Report pursuant to s42A Resource Management Act 1991

In the matter of:	A Notice of Requirement to construct and operate a new intermodal rail and freight hub on land between Palmerston North and Bunnythorpe
And:	A hearing by Palmerston North City Council pursuant to s100A
Requiring Authority:	KiwiRail Holdings Ltd
Hearing date:	9 August 2021

S42A Technical Evidence: Air Quality

By: Deborah Ryan

Figure 1. Dwellings within 100 metres of designation boundary (Source Kāhu)

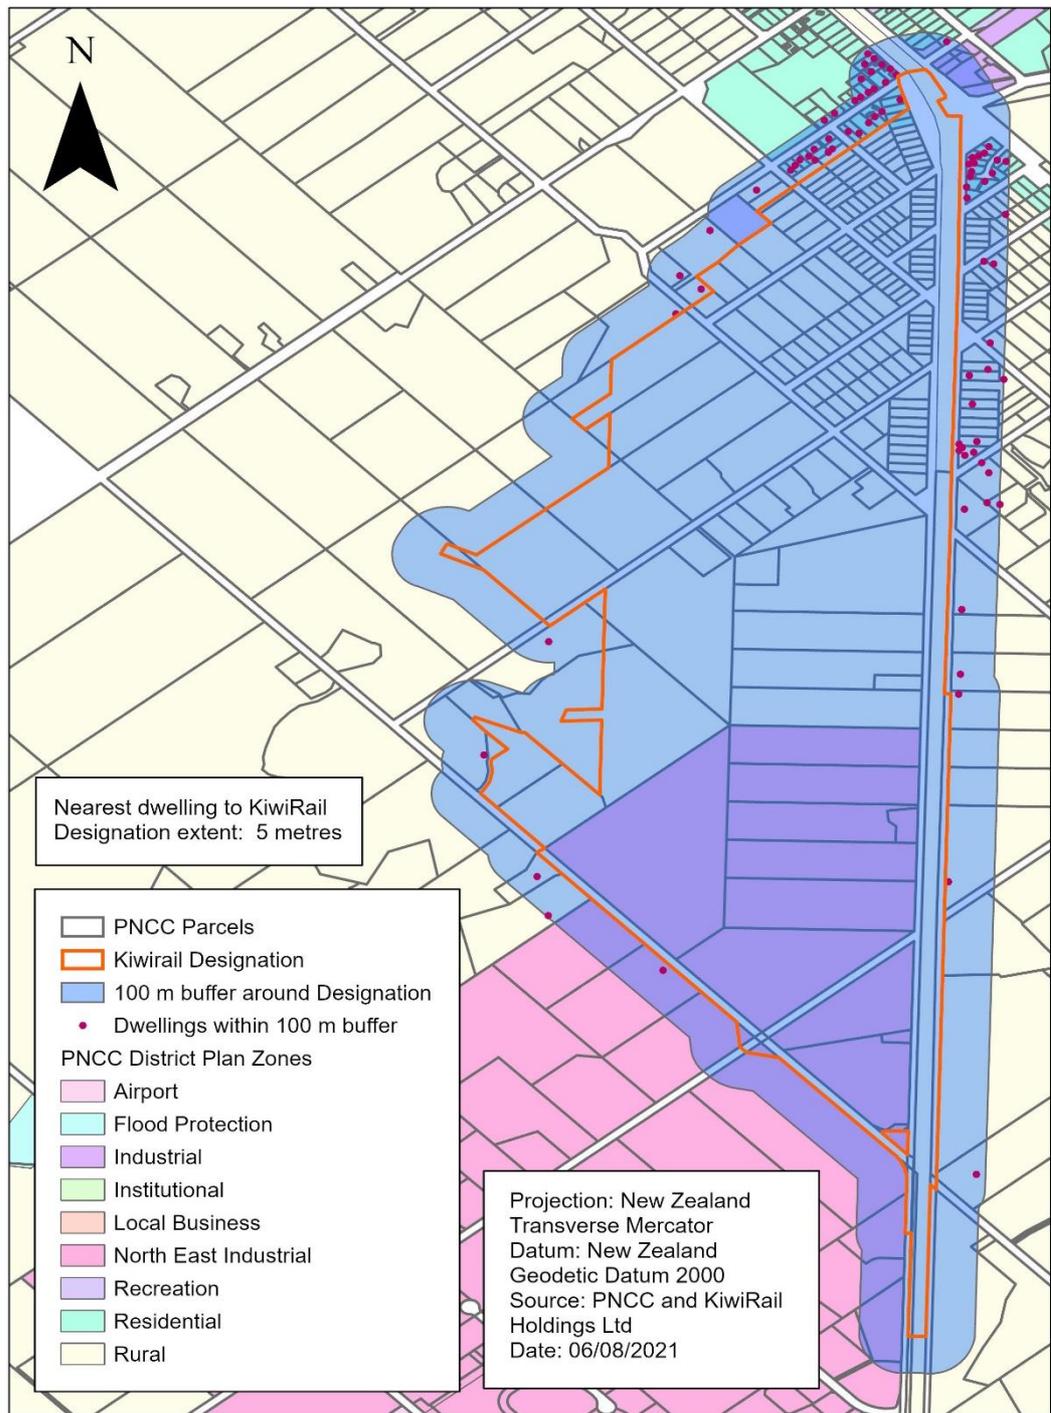
76. Figure 1 above shows dwellings within 100 metres of the designation boundary and is useful to help identify sensitive receptors for considering the potential for construction dust impacts.

- a. Dwellings on Maple Street and Te Ngaio Road are potentially exposed to dust when winds are principally from the east through to the south south-east (around 34% of time, 1.3 percent of which are greater than 7 m/s).

- b. Dwellings along Sangsters Road and Nathan Place are potentially exposed to dust when winds are from the south-southwest through to the north-northwest (around 49% of time, 5.9 percent of which are greater than 7 m/s).

- c. There are isolated dwellings on Cleverly Line and Roberts Line that may be downwind of the site when winds are from the north through to the southeast.

77. All dwellings within 50 metres of construction works and/or those downwind of strong winds greater than 7m/s will be potentially significantly affected by dust. I consider that specific mitigation measures are likely to be needed during construction due to the sensitivity of the environment particularly, when works are near to the northern and eastern boundaries of the Freight Hub site or

individual dwellings at Roberts Line and Cleverly Line. Additional mitigation measures for dwellings at high risk of dust effects are set out in paragraphs 87 and 88 below.

Figure 2. Palmerston North Airport Wind Rose, 2015 – 2019

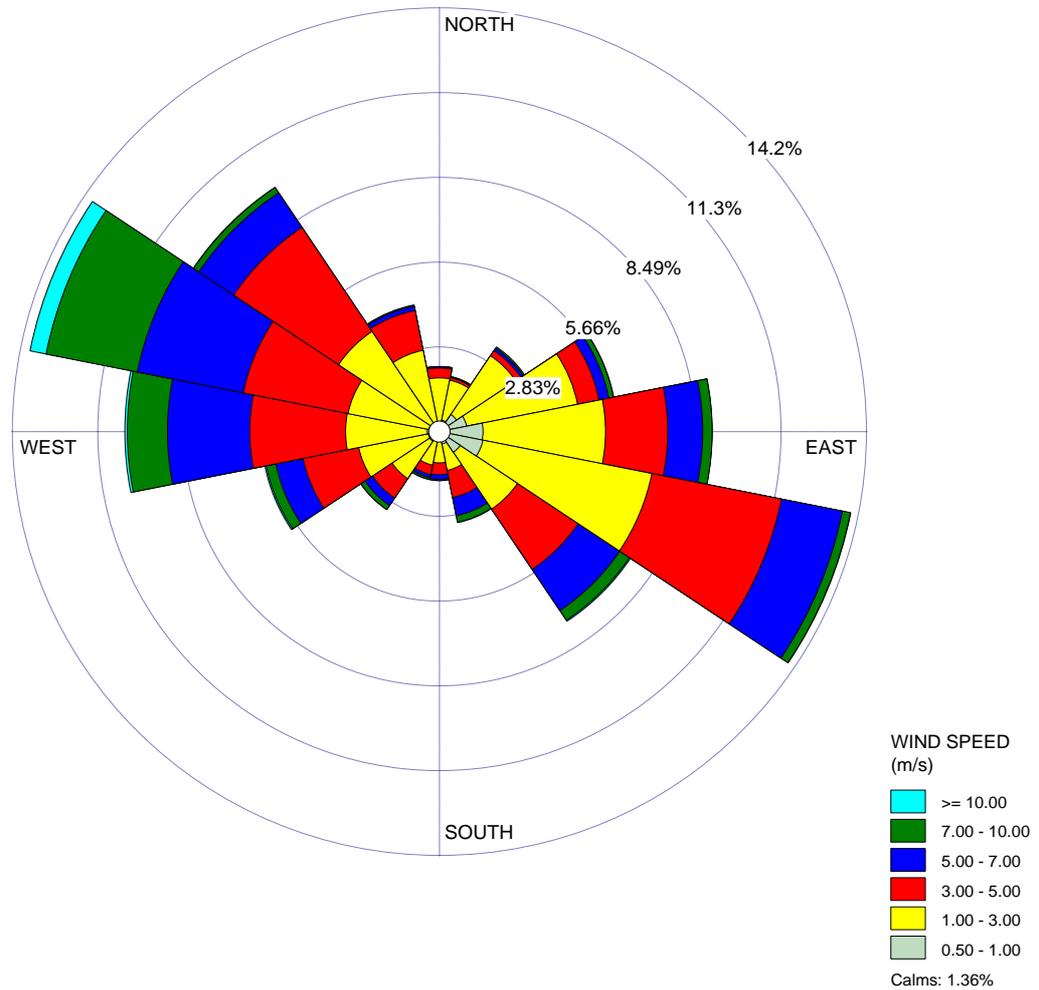
70. The wind rose provided by KiwiRail is not presented in metres per second (m/s), which is typically used for discussing the potential effects as they relate to wind speeds. I have therefore provided as Figure 2, a windrose prepared by PDP for the Palmerston North Airport to help inform my assessment. PDP's windrose shows the same general patterns but has a more useful parametrisation of the wind speeds.

71. The winds occur predominantly along the west-northwest and east-southeast axis. Winds from the west-northwest are also the strongest with the highest

frequency of wind speeds greater than 7 m/s, with winds greater than 10 m/s from the west-northwest occurring around 0.8% of the time.

72. Dust may be generated by wind on exposed surfaces and remain suspended in air when speeds exceed 7 m/s. Regardless of wind, dust may also be generated through mechanical activities undertaken on-site, such as vehicle movements on unsealed haul roads or placement of fill. Dwellings that are either very close to the boundary where activities such as bund construction will occur, or downwind of exposed surfaces when wind speeds exceed 7 m/s are at the highest risk of experiencing adverse effects from dust.
73. While the Dust GPG states that 10 m/s can be a wind speed trigger for work to cease, the relevant wind speed depends on the height that monitoring is being undertaken. I understand that the Dust GPG level relates to wind

monitoring at a height of 10 metres. I am aware that some quarries are applying a 7 m/s wind speed to cease dust producing activities, particularly near boundaries with nearby dwellings and that on-site meteorological monitoring is typically undertaken at lower heights. I have recommended on-site monitoring of wind conditions at a height not exceeding 5 metres to inform dust management.
